APPLICATION NO.	FILING DATE	FIRST NAMED INVENTOR	ATTORNEY DOCKET NO.	CONFIRMATION NO.	
10/645,870	08/22/2003	Tetsuya Uda	62807-137	8647	
20277	20277 7590 04/19/2005			EXAMINER	
MCDERMOTT WILL & EMERY LLP 600 13TH STREET, N.W.			ROJAS, OMAR R		
WASHINGTON, DC 20005-3096			ART UNIT	PAPER NUMBER	
			2874		
			DATE MAILED: 04/19/2005

Application No.	Applicant(s)				
	10/645,870	UDA, TETSUYA				
Office Action Summary	Examiner	Art Unit				
	Omar Rojas	2874				
The MAILING DATE of this communication app Period for Reply	ears on the cover sheet with the c	orrespondence address				
A SHORTENED STATUTORY PERIOD FOR REPLY THE MAILING DATE OF THIS COMMUNICATION. - Extensions of time may be available under the provisions of 37 CFR 1.13 after SIX (6) MONTHS from the mailing date of this communication. - If the period for reply specified above is less than thirty (30) days, a reply If NO period for reply is specified above, the maximum statutory period w - Failure to reply within the set or extended period for reply will, by statute, Any reply received by the Office later than three months after the mailing earned patent term adjustment. See 37 CFR 1.704(b).	36(a). In no event, however, may a re

Matsuoka discloses in Figure 4 (reproduced below) an optical transmission apparatus for amplifying wavelength-division multiplexed light received from a first optical transmission line and supplying it to a second optical transmission line, comprising:

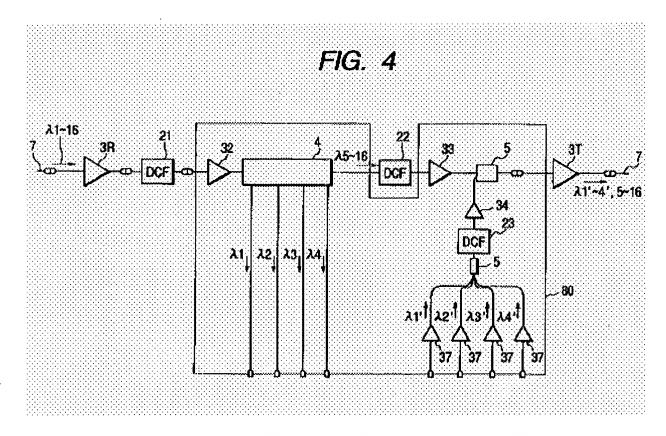
6. Claims 1, 4, 5, and 12 are rejected under 35 U.S.C. 102(b) as being clearly anticipated by Patent Publication 2001/0024544 to Matsuoka et al. (hereinafter "Matsuoka").

an optical amplifier (3R, 3T) for amplifying said wavelength-division multiplexed light; a first chromatic dispersion compensator 21 for compensating for chromatic dispersion caused during the transmission of said wavelength-division multiplexed light from a first predetermined position on said first optical transmission line to said optical transmission apparatus;

and a second chromatic dispersion compensator (22, 23) for compensating for chromatic dispersion caused during the transmission of said wavelength-division multiplexed light between said optical transmission apparatus and a second predetermined position on said second optical transmission line.

Regarding claim 4, said optical amplifier includes a first optical amplifier 3R provided between said first optical transmission line and said first chromatic dispersion compensator 21, and a second optical amplifier 3T provided between said second chromatic dispersion compensator 22 and said second optical transmission line.

Regarding claim 5, Matsuoka further teaches an add-drop portion 80.

Regarding claim 1, Grasso shows in Figure 5 (reproduced below) an optical transmission apparatus for amplifying wavelength-division multiplexed light received from a first optical transmission line and supplying it to a second optical transmission line, comprising:

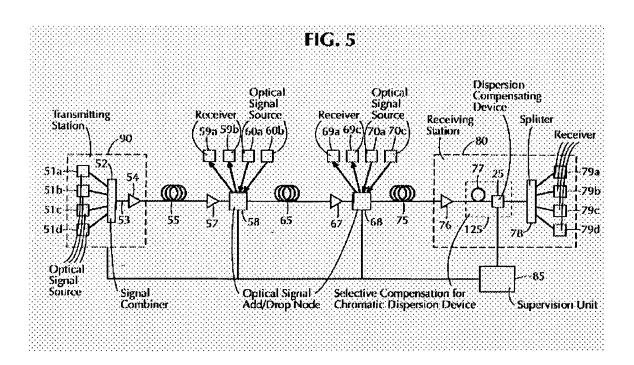
7. Claims 1-5 and 12 are rejected under 35 U.S.C. 102(b) as being clearly anticipated by Patent No. 5,943,151 to Grasso et al. (hereinafter "Grasso").

an optical amplifier 57 for amplifying said wavelength-division multiplexed light;

a first chromatic dispersion compensator (see Figure 6 and column 16, lines 47-55) for compensating for chromatic dispersion caused during the transmission of said wavelength-division multiplexed light from a first predetermined position on said first optical transmission line to said optical transmission apparatus;

and a second chromatic dispersion compensator (see Figure 6 and column 16, lines 47-55) for compensating for chromatic dispersion caused during the transmission of said wavelength-division multiplexed light between said optical transmission apparatus and a second predetermined position on said second optical transmission line.

Regarding claim 2, Grasso shows an add drop portion 58 between said first and second chromatic dispersion compensators, said add drop portion 58 having wavelength-dropping means for dropping an optical signal of a predetermined band from said wavelength-division multiplexed light, and wavelength-adding means for multiplexing an optical signal of a certain band with said wavelength-division multiplexed light.

Regarding claim 4, said optical amplifier includes a first optical amplifier 57 provided between said first optical transmission line and said first chromatic dispersion compensator, and a second optical amplifier 67 provided between said second chromatic dispersion compensator and said second optical transmission line.
